**MINUTES**  
**WORCESTER TOWNSHIP PLANNING COMMISSION**  
**WORCESTER TOWNSHIP COMMUNITY HALL**  
**1031 VALLEY FORGE ROAD, WORCESTER, PA 19490**  
**THURSDAY, NOVEMBER 21st, 2024 - 7:00 PM**

Reference: 1205 Hollow Road  
Parcel No. 67-00-01303-00-7  
Wangia Subdivision Plan Review (2<sup>nd</sup> Review)  
Worcester Twp. LD 2024-01

Reference: 1507 Potshop Road  
Parcel No. 67-00-02821-00-1  
Concept Plan Review  
Worcester Twp. LD 2024-04

RE: **Traffic Review #1 – Transportation Impact Study (TIS) Scoping Meeting Application/  
Sketch Plan**  
1507 Potshop Road (S.R. 3004) – 11 Lots  
Worcester Township, Montgomery County, PA  
Project No. 313982-24-004

FIELD PERSONNEL	SHEET TITLE
MC/ASA/RTE	MAJOR SUBDIVISION
DESIGNED BY: PJC	DRAWN BY: WFWS
CHECKED BY: PJC	PROJECT NO: WANGBR0001
DATE: 05/20/2024	
PLAN SCALE: 1" = 50'	CADD FILE: 2024-05-20 - Wangia-1205 Hollow
SHEET NO: 1 of 1

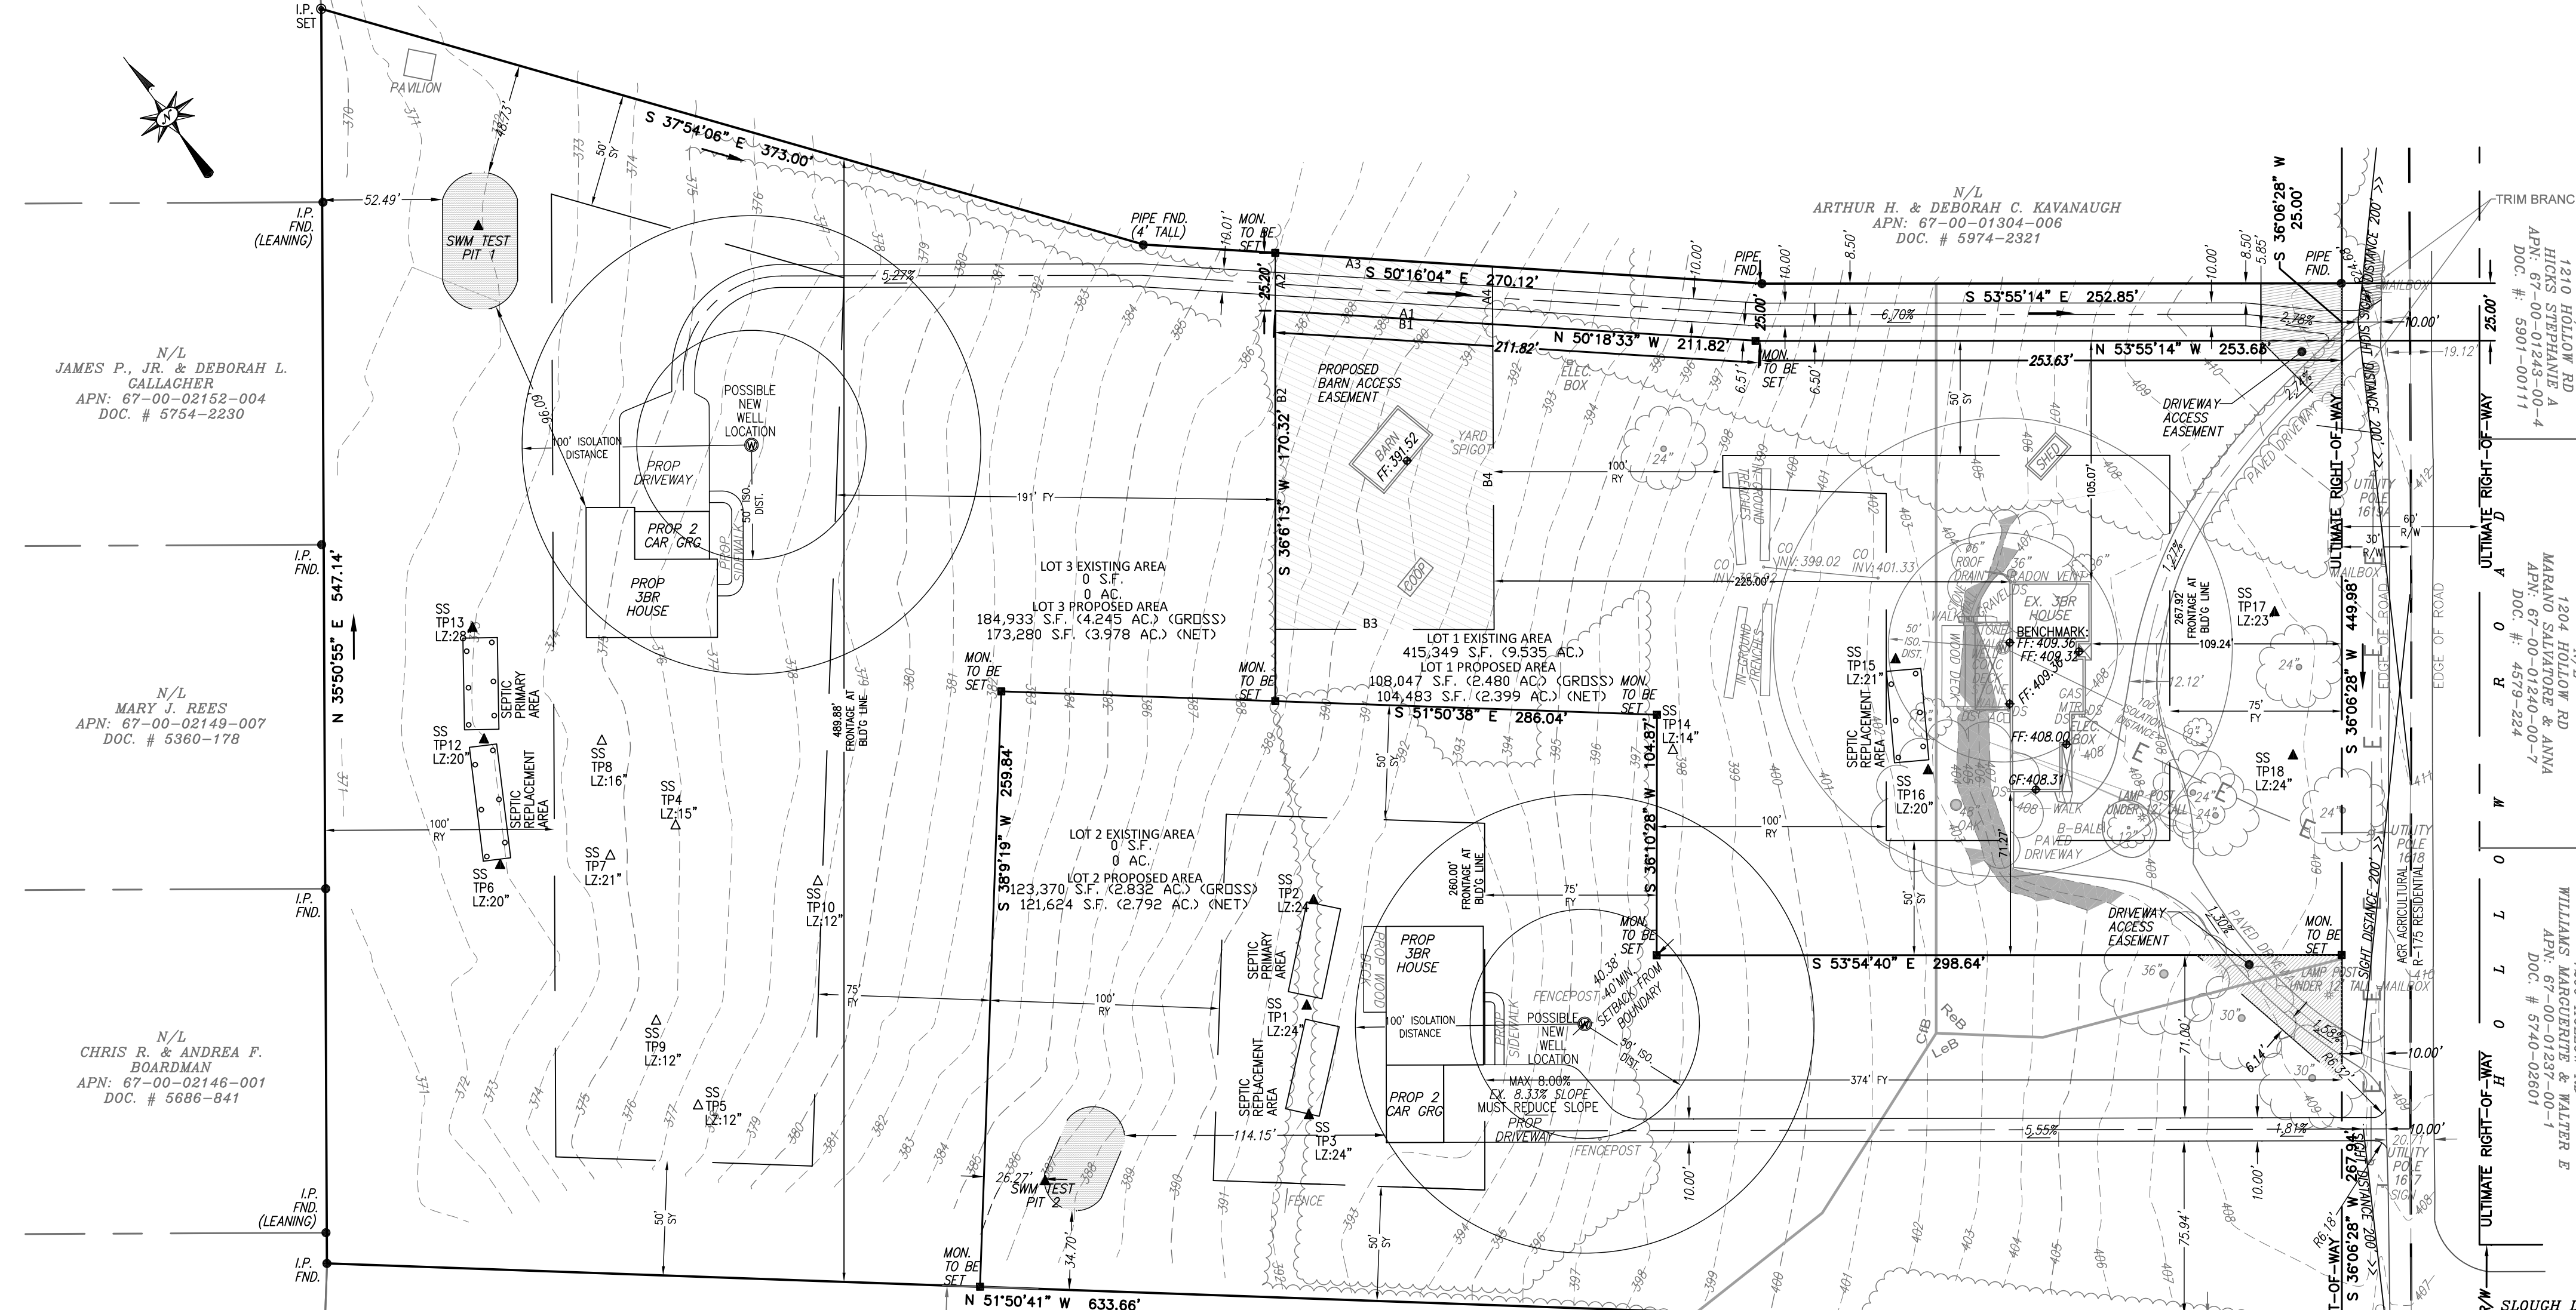
3. This office previously questioned the purpose of the easement(s) at the barn on Lot 1 (B1-B4). The plans have been revised to indicate the easement is proposed. The applicant must provide additional information regarding the barn's use - is it for livestock or storage? Additionally, a dimension from the property line to the barn must be added to the plans. Finally, the rear yard setback must be from the property line and not the easement.

3. A significant number of trees would need to be removed to accommodate development on part of Lot 2 and most of Lot 3. A separate tree survey plan must be provided indicating all trees with a diameter breast height (DBH) of six inches or more. Replacement trees may be required, depending on the extent of removals necessary for development of Lots 2 and 3. The applicant's response indicated that this requirement will be completed during future building applications. If this request is approved, it must be noted on the plans. (SLDO 130-28.E)

4. Street trees are required. Presently, there are several mature trees located along the property frontage. The Township will need to determine if the existing trees are satisfactory or if they must be supplemented by new plantings at appropriate spacing and setback from the right-of-way. (SLDO 130-28.G.4)

5. The metes and bounds of all lot lines associated with the proposed lots must be specified on the plans. The southerly side property line of Lots 2 and 3 should have separate distances split by the monument.

6. We note several variations between the metes and bounds as described in the property's deed relative to the data listed on the submitted plan. A registered professional land surveyor licensed in the Commonwealth of Pennsylvania must sign and seal the plans and certify the error of closure being no greater than 1:2,500. (SLDO 130-34.J.2.b)

7. The applicant should confirm that there are no deed restrictions or covenants that would otherwise prohibit the subdivision of this lot. We note that the subject tract was part of a prior lot line adjustment in 2014. Any restrictions must be noted on the Record Plan. (SLDO 130-34.J.2.h)

1. The applicant is requesting a waiver from **Section 130-18.A** of the **Subdivision and Land Development Ordinance**, requiring sidewalk to be provided along the site frontage of Hollow Road. The plan currently does not show any sidewalk along the Hollow Road site frontage, thereby not satisfying the ordinance requirement. Due to this being a minor subdivision, and since there is currently no sidewalk along either side of Hollow Road in the vicinity of the site, we recommend to the Board of Supervisors to consider deferring this obligation that is required of the applicant until such a time as may be required by the Township for these subdivided properties, whether

2. The applicant is requesting a waiver from **Section 130-18.B** of the **Subdivision and Land Development Ordinance**, requiring curbing to be provided along the site frontage of Hollow Road. The plan currently does not show any curbing along the Hollow Road site frontage, thereby not satisfying the ordinance requirement. Due to this being a minor subdivision, and since there is currently no curbing along either side of Hollow Road in the vicinity of the site, we recommend to the Board of Supervisors to consider deferring this obligation that is required of the applicant until such a time as may be required by the Township for these subdivided properties, whether under present or future land ownership, and at no cost to Worcester Township, or the Township may desire to consider a fee in lieu of curb to be kept in escrow for future curb installations in the Township and/or area of these properties.

4. According to **Section 130-16.C(1)(a)[6][a]** of the **Subdivision and Land Development Ordinance**, Hollow Road should have a 38-foot cartway width. The plan currently shows an approximate 19-foot cartway width along the site frontage of Hollow Road, thereby not satisfying the ordinance requirement. A waiver will need to be requested from the requirement of this ordinance section if a 38-foot (19 feet from centerline) cartway width will not be provided along the Hollow Road site frontage. Since the approximate 19-foot cartway width along the site frontage is consistent with the cartway width along most of Hollow Road in the vicinity of the site, Bowman is supportive to the granting of this waiver should the Board of Supervisors grant this request.

5. The applicant is providing a shared driveway for Lot 1 (existing home) and Lot 3 (flag lot home with access along northern boundary of Lot 1) as indicated on the plan via provision of a driveway access easement. Our office concurs with provision of a shared driveway for Lots 1 and 3 as it will improve access management along this portion of Hollow Road. However, the proposed access easement metes and bounds description, and executed legal documentation must be included in subsequent submissions for review and concurrence by the Township, the Township solicitor, the Township Engineer, and our office.

6. The existing southern driveway to Lot 1 along Hollow Road will be located on the Lot 2 property once the overall property is subdivided. An access easement between the owner of Lot 1 and the owner of Lot 2 is being provided for this condition as indicated on the plan. The proposed access easement metes and bounds description, and executed legal documentation must be included in subsequent submissions for review and concurrence by the Township, the Township solicitor, the Township Engineer, and our office.

# CONCEPT PLAN 1507 POTSHOP ROAD CONSERVATION SUBDIVISION PLAN

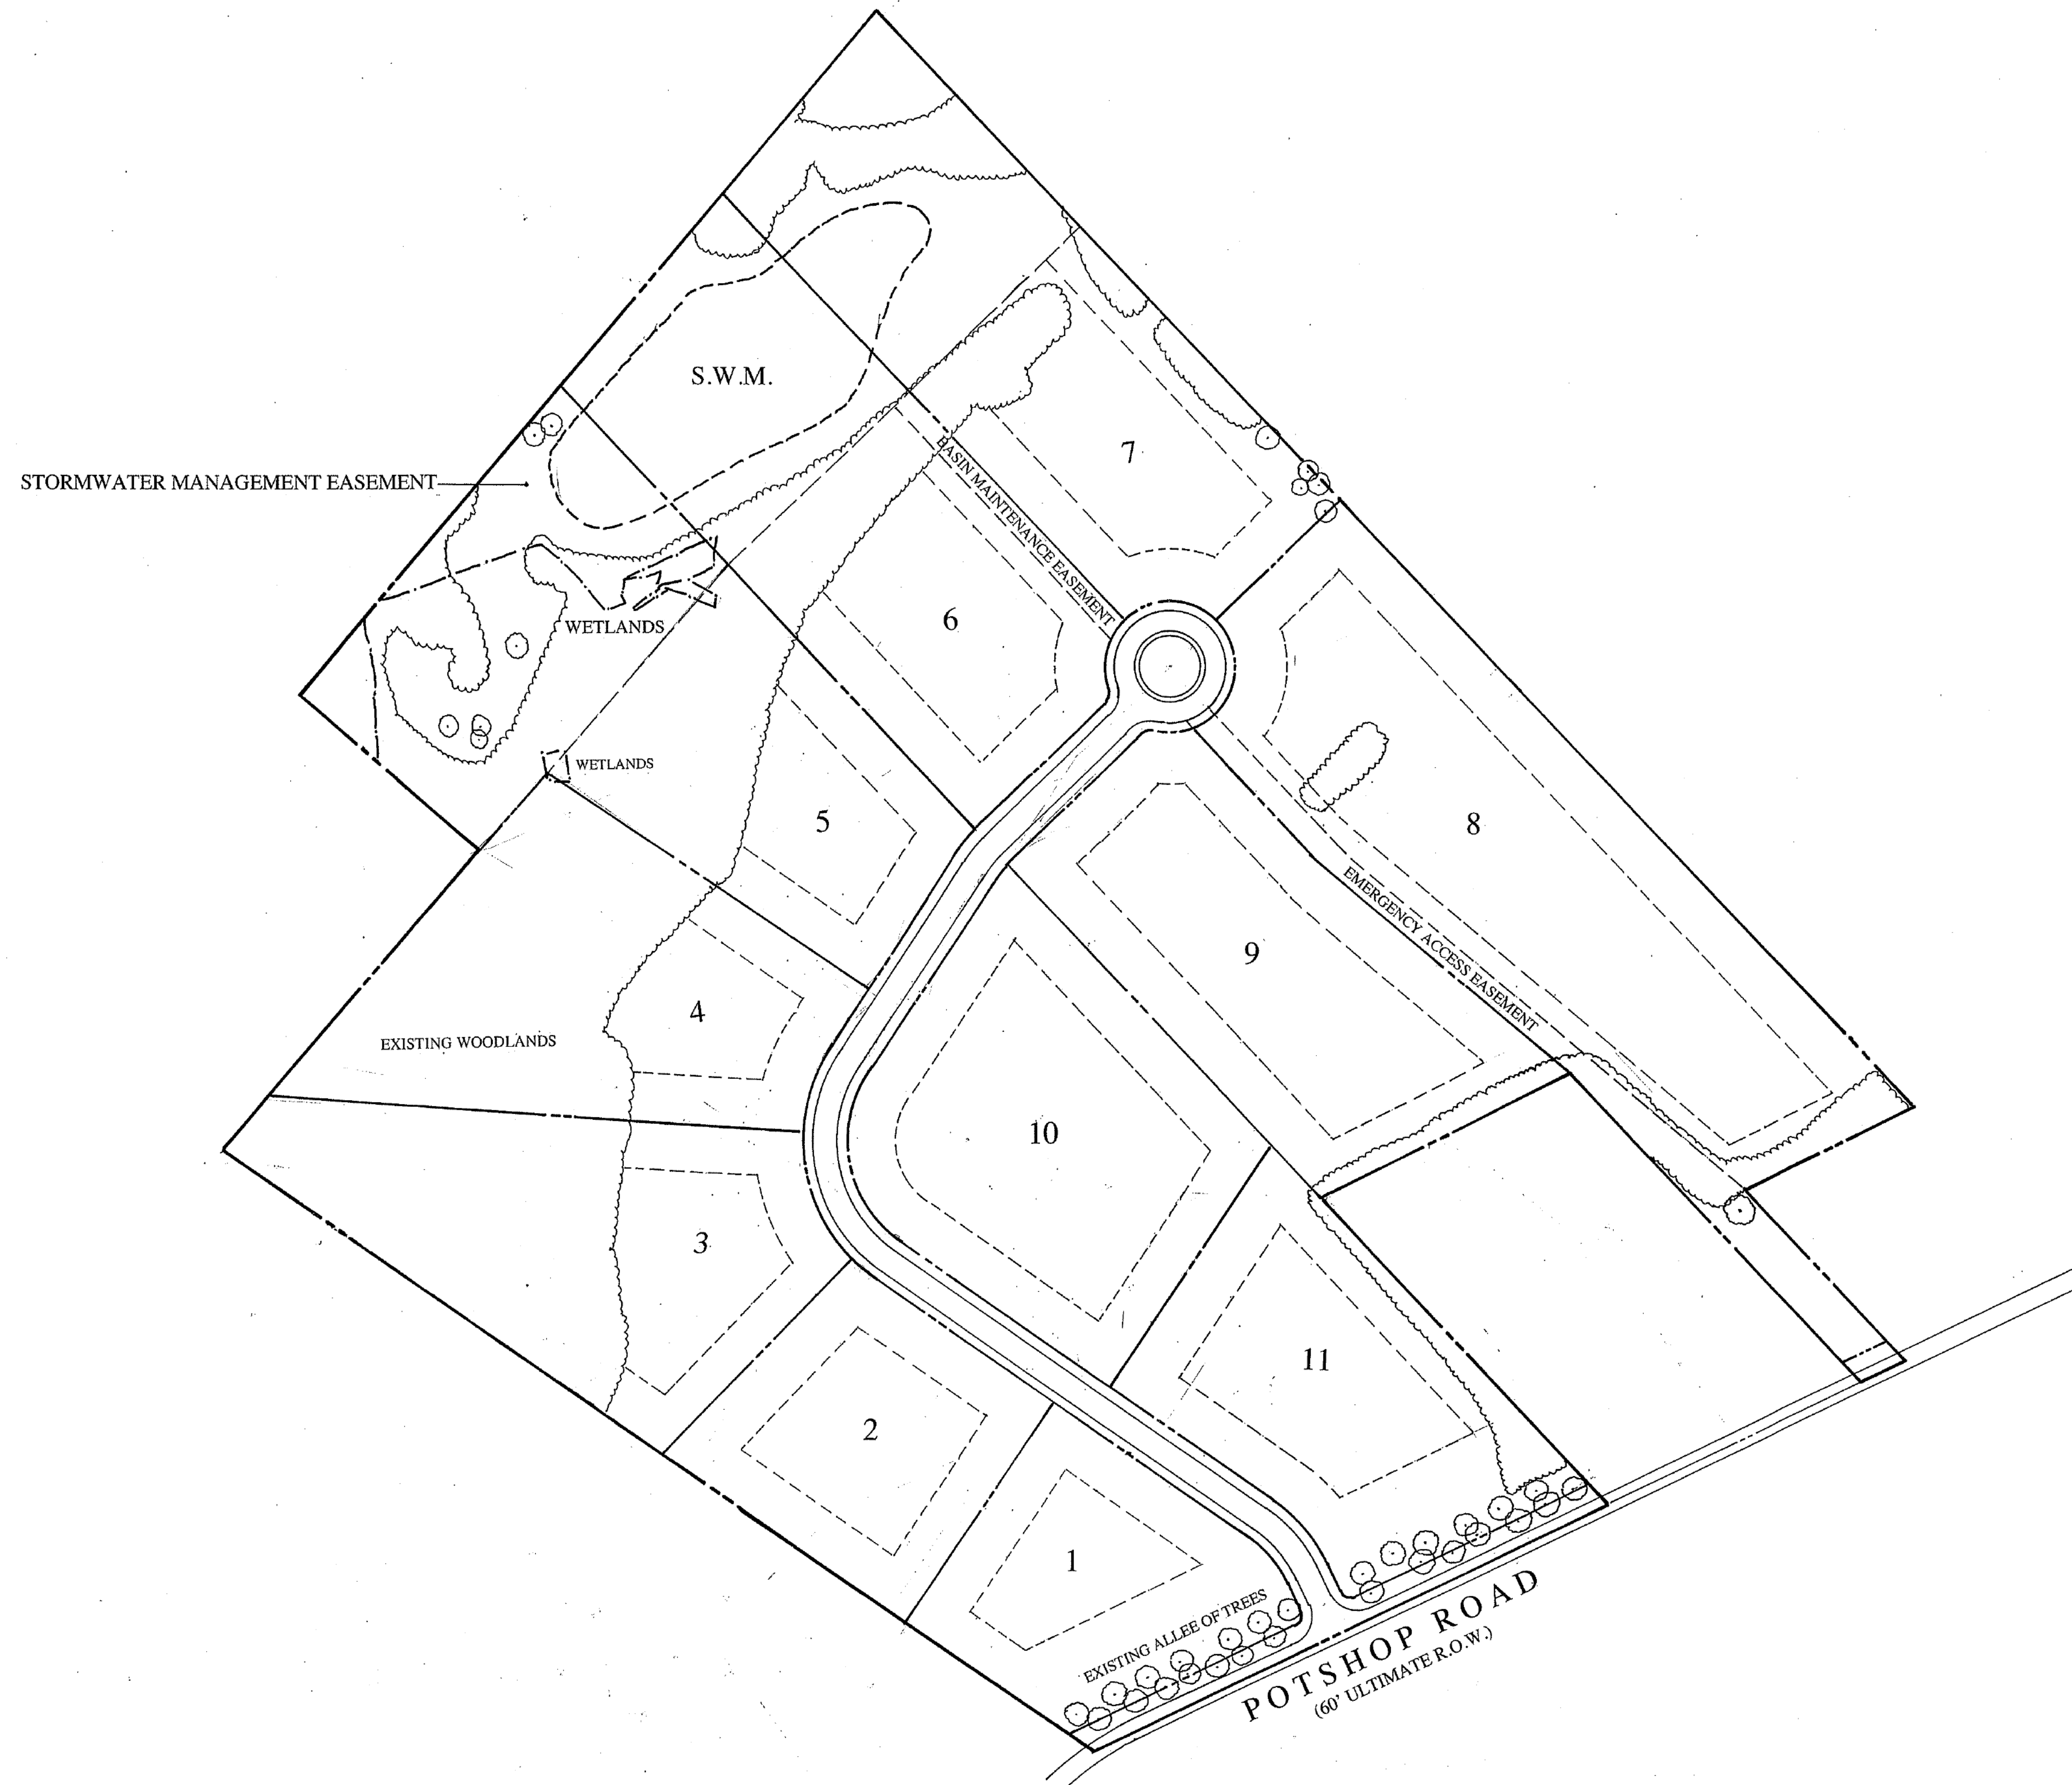
1. The proposed use, Estate Lots developed in accordance with the standards of Conservation Subdivisions, is permitted in the AGR zoning district for tracts which are over eight acres. (150-11.2 and 150-110.2.A.1.b)
2. The plan must provide a dimensional compliance chart for each of the proposed 11 lots. The sketch plan indicates general compliance of all proposed lots with the lot area, lot width, lot frontage, and yard requirements of the ordinance. Conceptually, there is no immediate, observable need for variances; however, we are unable to provide a definitive

review of the individual lot conditions depicted on the sketch plan due to the limited detail. The eleven (11) lot development density is acceptable and is the maximum quantity of Estate Lots that could be established on this tract. (150-110.3.B and 150-110.6)

3. The yards provided should be dimensioned and labeled. We note that Lots 3 through 7 all contain woodlands at their rear. Lots 1 and 11 are corner lots with Potshop Road and must provide a 100-foot setback from the secondary street.
4. Lots shall be permanently restricted from future subdivision and land development by a deed restriction enforced by the Township or by a conservation easement held by the Township or a qualified conservation organization. The organization and the terms and form of the easement shall be approved by the Township. (150-110.2.E)
5. The proposed ultimate right-of-way half-width for Potshop Road must be dimensioned and labeled. (150-186)
6. The applicant must demonstrate that the stormwater basin does not occupy more than 25% of any required yard area taken as both a linear measurement and surface area measurement. (150-203)

1. Lot 8 provides for an emergency access easement which extends to Potshop Road. The size, paving materials, clearances, and maintenance responsibilities of the area will need to be discussed. The location of the emergency access should be presented to the Township Fire Marshal for review and comment prior to submission of any Preliminary/Final Plan. A depressed curb into the cul-de-sac should be provided. We recommend that a knock-down bollards or other similar barrier be installed at the edge of the right-of-way.

3. The plans suggest that a majority of the trees along the frontage of Potshop Road are to be maintained. An adequate sight triangle must be achieved for the new intersection. Required and provided sight distances must be shown on future submissions. (130-16.B(1))

5. The applicant should clarify if the proposed cul-de-sac roadway will be offered for public dedication or private and maintained by a homeowners association.

6. The nature of improvements associated with the new road are unclear. The applicant should discuss with the Planning Commission if there will be sidewalks, curbing, street trees, buffer plantings, basin plantings, street lights, driveway aprons, etc. The only improvement shown is a center island within the cul-de-sac area; however, it is also unclear if this will be curbed/landscaped. (130-18, 130-28.G.4, G.5 and G.7)

11. The type of water and sewer service must be noted on future plans. Isolation areas for wells and on-lot septic disposal areas must be identified. (130-26 and 130-31.C; 150-184 and 150-185)

10. The cartway width along the Potshop Road (S.R. 3004) site frontage should be clearly labeled on the plan and be in accordance with **Section 130-16.C** of the **Subdivision and Land Development Ordinance**.

11. A note must be added to the plan stating that the area between legal right-of-way line and ultimate right-of-way line along the Potshop Road (S.R. 3004) site frontage should be offered for dedication to the authority having jurisdiction over the road as required by **Section 130-16.C(2)(c)** of the **Subdivision and Land Development Ordinance**.

12. Adequate sight distance measurements should be shown on the plan for the proposed roadway along Potshop Road (S.R. 3004), as well as for the proposed emergency access along Potshop Road (S.R. 3004), as required by **Section 130-16.E(5)** of the **Subdivision and Land Development Ordinance**. Specifically, vehicular egress sight distances looking in both directions must be provided, as well as for the ingressing left-turn vehicle sight distance to the front and rear, and achievable sight distances must be sufficient for the speed and conditions to allow for all ingress and egress turning movements and the roadway/driveway locations as they exist/are proposed on the plan. Vegetation and physical restrictions along the property frontage must be cleared and maintained to allow for at least the minimum safe stopping distances to be achieved at 14.5 feet back from the edge of the road for the proposed roadway and at 10 feet back from the edge of the road for the proposed emergency access.

13. According to **Section 130-18.A** of the **Subdivision and Land Development Ordinance**, sidewalk should be provided along the site frontage of Potshop Road (S.R. 3004). The plan currently does not show any sidewalk along the Potshop Road (S.R. 3004) site frontage, thereby not satisfying the ordinance requirement. Due to this being a minor subdivision, and since there is currently no sidewalk along either side of Potshop Road (S.R. 3004) in the vicinity of the site, we note at this sketch plan stage that the Board of Supervisors may consider deferring this obligation that is required of the applicant until such a time as may be required by the Township for the development of this property, whether under present or future land ownership, and at no cost to Worcester Township, or the Township may desire to consider a fee in lieu of sidewalk to be kept in escrow for future sidewalk installations in the Township and/or area of these properties.

14. Sidewalk should be shown on the plan along the proposed roadway as required in **Section 130-18.A** of the **Subdivision and Land Development Ordinance**.

15. According to **Section 130-18.B** of the **Subdivision and Land Development Ordinance**, curbing should be provided along the site frontage of Potshop Road (S.R. 3004). The plan currently does not show any curbing along the Potshop Road (S.R. 3004) site frontage, thereby not satisfying the ordinance requirement. Due to this being a minor subdivision, and since there is currently no curbing along either side of Potshop Road (S.R. 3004) in the vicinity of the site, we note at this sketch plan stage that the Board of Supervisors may consider deferring this obligation that is required of the applicant until such a time as may be required by the Township for these subdivided properties, whether under present or future land ownership, and at no cost to Worcester Township, or the Township may desire to consider a fee in lieu of curb to be kept in escrow for future curb installations in the Township and/or area of these properties.

16. The curb radius and ultimate right-of-way radius for the cul-de-sac portion of the proposed roadway should be labeled on the plan and meet requirements in **Section 130-16.C(1)(a)[5][b][ii]** of the **Subdivision and Land Development Ordinance**.

17. According to **Section 130-16.C(1)(a)[5][b][v]** of the **Subdivision and Land Development Ordinance**, cul-de-sacs shall not be longer than 500 feet in length. The plan currently shows a cul-de-sac length of **more than 500 feet**, thereby not satisfying the ordinance requirement. A waiver will need to be requested from this ordinance requirement and approved by the Township Board of Supervisors.

18. The curb radii should be labeled on the plan at the proposed roadway intersection with Potshop Road (S.R. 3004) and be in accordance with **Section 130-16.E(8)** of the **Subdivision and Land Development Ordinance**.

19. Horizontal curvature information should be provided on the plan for the proposed roadway and be in accordance with **Section 130-16.B(2)** of the **Subdivision and Land Development Ordinance**.

21. Additional details for the proposed driveways to Lots 1 to 11 must be added to the plan. The driveways must be designed in accordance with **Section 130-17.B(3)** of the **Subdivision and Land Development Ordinance** with respect to grades, widths, and offsets to the property lines, etc.
